## PLANNING AND DEVELOPMENT SERVICES

**Re: DRH19-00284 | 1114 W Front Street | C-5DD**

The Boise City Planning and Development Services Department has approved your request, with the attached Conditions of Approval to construct an enclosed outdoor patio in the C-5DD (Central Business with Downtown Design Review Overlay) zone.

**Figure 11-12.2: Clear vision triangle at a street and driveway/alley intersection**

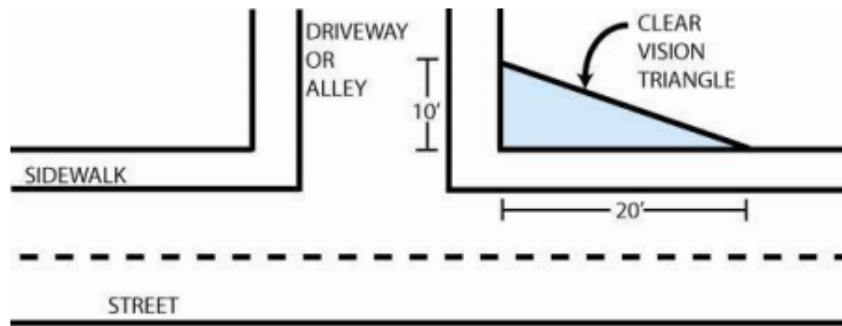
- c. Patio enclosure shall be no taller than 3' within the clear vision triangle. Street and driveway intersection clear vision triangle diagram may be found within the Findings section.

Sections of the proposed patio enclosure are located within the clear vision triangle of the curb access from Front Street. Where a driveway enters the street right-of-way, a clear vision triangle shall be formed horizontally, by measuring 10 feet into the lot as measured from the sidewalk edge that is closest to the property line, and 20 feet along the sidewalk edge, parallel to the street, and vertically by measuring between three feet and ten feet above grade. As conditioned, the enclosure shall be no taller than 3' within the clear vision triangle in order to preserve visibility and vehicular and pedestrian safety.
